Town of Parker Community Development Department
Development Review Division
Attention: **Julia Duncan**

Application Type: **Site Plan**
Status: **First Referral**
Application Name: Parker Pointe F1 AMD 1 L4A - Drive Through Coffee Shop
Case/AP#: **SP24-128**
Referral Received: January 3, 2025
Comments Due: February 3, 2025

Review date: **January 15, 2025**

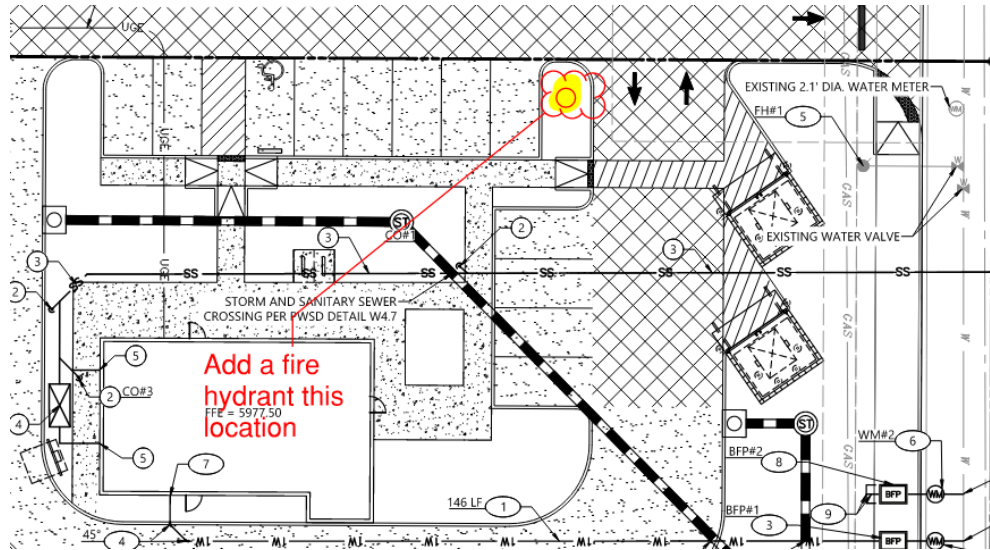
2. The applicant shall be aware that **no vertical construction on this site will be allowed until such time that curb gutter and first lift of asphalt are installed**; a site inspection will be required to ensure that this requirement is made prior to allowing vertical construction to commence.
3. The applicant shall be aware that the access road hydrant distribution was not planned to address the suppression needs for all commercial properties within this subdivision; this site requires the addition of one hydrant (to be located at the s/e corner island of the building... as required per NFPA 24 Section 7.2.3. The hydrant shall be

located within 40 feet of the building to be served. A fire hydrant shall be provided and located in the northeast island (see below) and address this issue when resubmitting,

Commentary Figure 503.1.1(3) SMALL BUILDING ACCESS

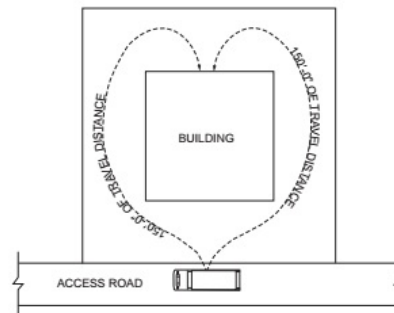
5. Per the requirements of the 2021 IFC Section 503.1.1, approved fire apparatus access roads shall be provided to for every facility such that the requirements of this section extend to within 150 feet of all facility and all portions of all exterior walls of the first story of the building as measured by an "approved route". In the event that this cannot be achieved, the fire code official is allowed to increase that distance so long as the building is fully sprinklered per 903 of the 2021 IFC. While it appears that the applicant may be able to meet the requirements of the code, the applicant shall prepare and provide an exhibit that "proves that the access can be met. Please note, hose does not bend at 90 degrees and the applicant's exhibit shall mimic the exhibit provided in the 2021 IFC Handbook. To aid the applicant with what this looks like, please see the following and address this issue when resubmitting (measurement shall be taken centerline of the access road on the north side of the lot).

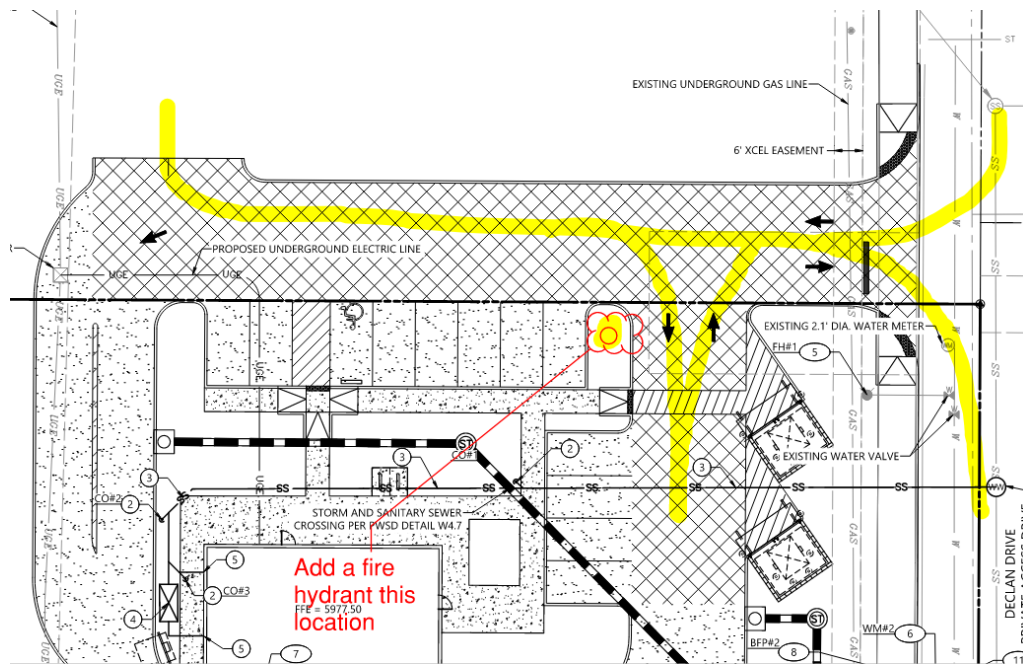
6. In the event that the building needs to be sprinklered, the riser room shall be located in an accessible location (northeast corner of the building) and shall meet the following requirements:

The riser room shall be sized to accommodate the following:

- The underground fire line is not allowed to have domestic tapped off of it
- The sprinkler riser is allowed to enter no further than 24-inches into the building (and any less than 12-inches into the building).

- A three-foot clearance shall be provided in front of the riser (with 18" of clearance on either side of the riser).
- The fire alarm control panel (FACP) is required to be located on an interior wall.
- A three-foot clearance is required in front of the FACP.
- Exterior access is required to be provided into the riser room; this access shall be approved.
- Access into the building shall be provided through the riser room or immediately adjacent to the riser room.
- While domestic water can be located in the riser room, the domestic cannot be located in any way that conflicts with the access requirements for both the FACP and the sprinkler riser.
- A sidewalk is required to the riser room and a 5 x 5 pad is required in front of the FDC.

The applicant shall **provide a floor plan of how the riser room is to be laid** out to avoid conflicts with the site plan once the building review submittal has been made; this project will not be approved without this requirement having been met and approved.

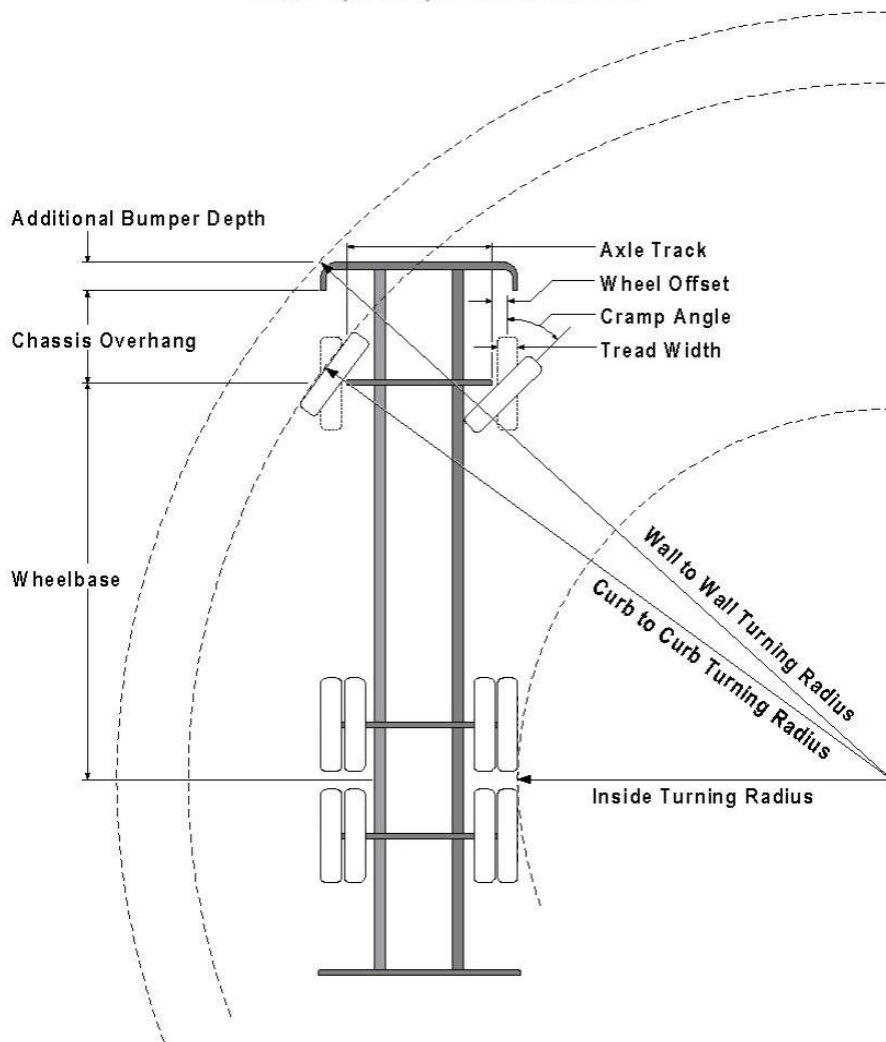
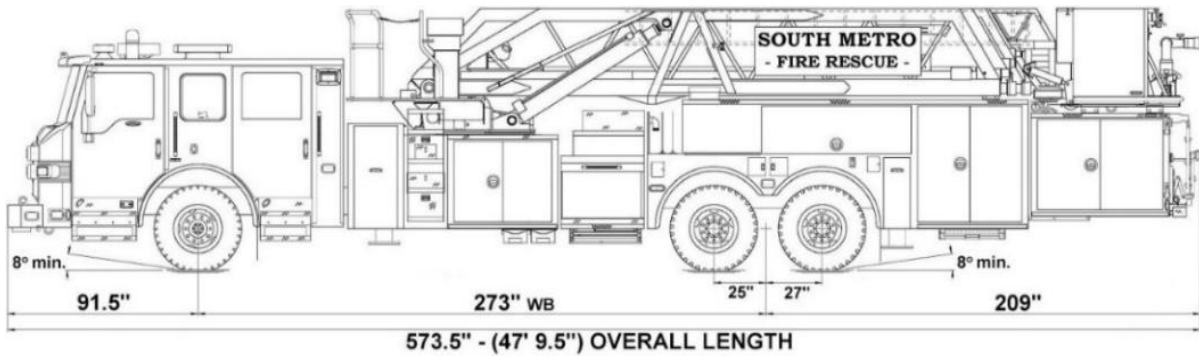
7. The applicant had not provided the required auto turn for the analysis, when resubmitting, provide an auto turn analysis for all areas shown below when resubmitting (note – failure to provide the analysis in all areas will result in delaying approval for the project).
